AMENDMENTS TO THE DRAWINGS:

SELWAY, James W.
Appl. No. 10/530,011
Response to Office Action dated August 22, 2006

Figure 1

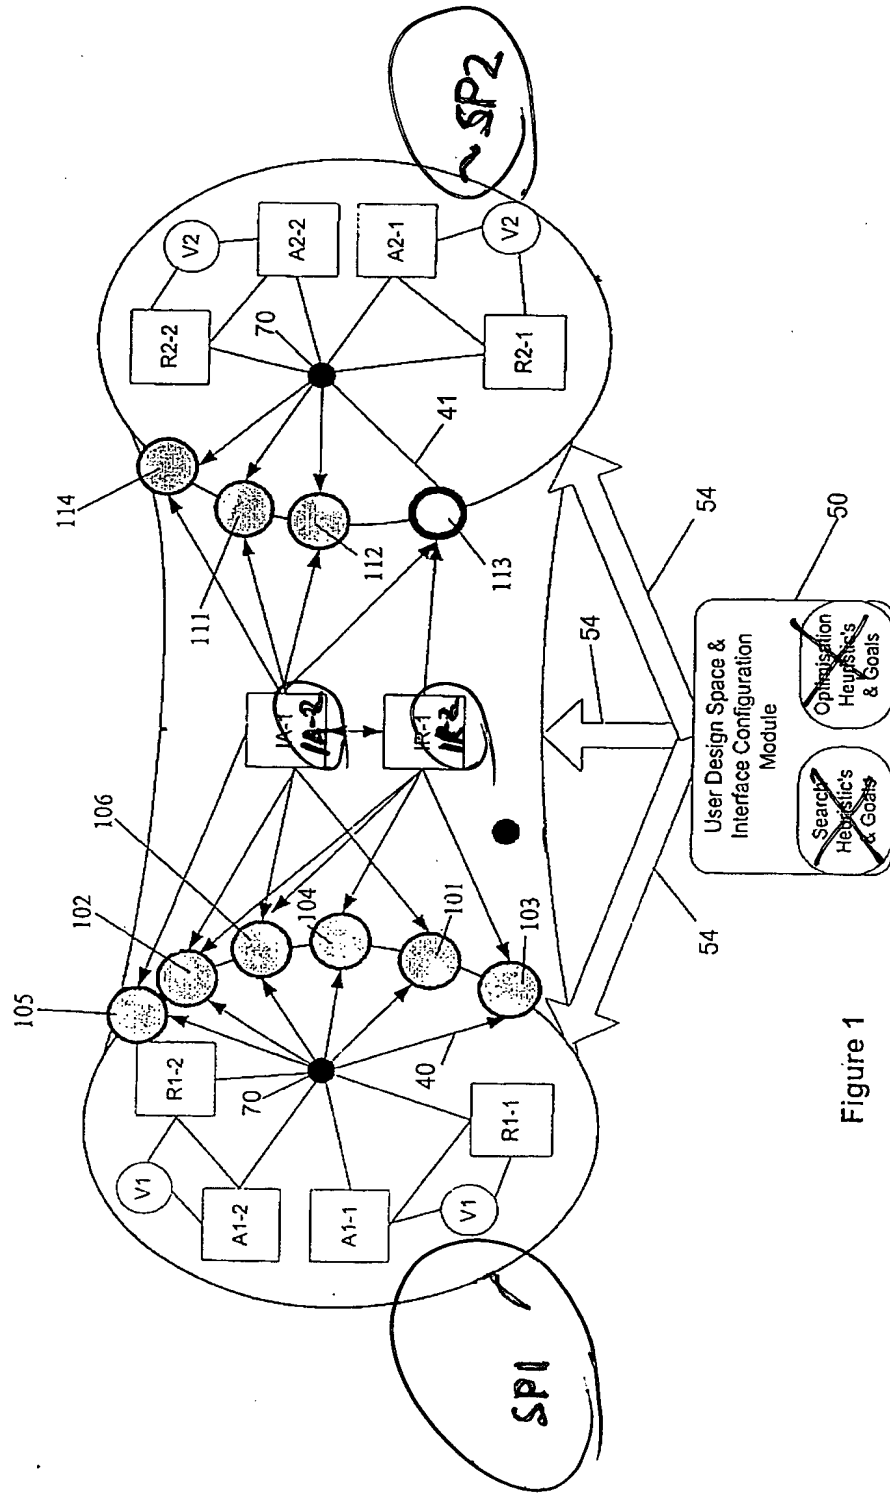
Figure 1 has been marked to show subprocesses 1 and 2 as SP1 and SP2. The second interface algorithm in the second interface rule IA-2 and IR-2 were omitted from original Figure 1. These are shown as co-located with IA-1 and IR-1 in amended Figure 1. In Figure 2, reference numeral 58 has been added and reference numeral 59 has been moved.

With respect to the objection to the drawings as allegedly failing to include certain reference sign(s) mentioned in the description as set forth in item 4 of the office action, the specification at page 12, line 27 has been amended to refer to “the second subprocess (SP2)” and Figure 1 has been marked to show subprocesses 1 and 2 as SP1 and SP2. The second interface algorithm in the second interface rule IA-2 and IR-2 were omitted from original Figure 1. These are shown as co-located with IA-1 and IR-1 in amended Figure 1. In Figure 2, reference numeral 58 has been added and reference numeral 59 has been moved. Finally, reference numeral 1 mentioned on page 22, line 36 has been changed to SP1.
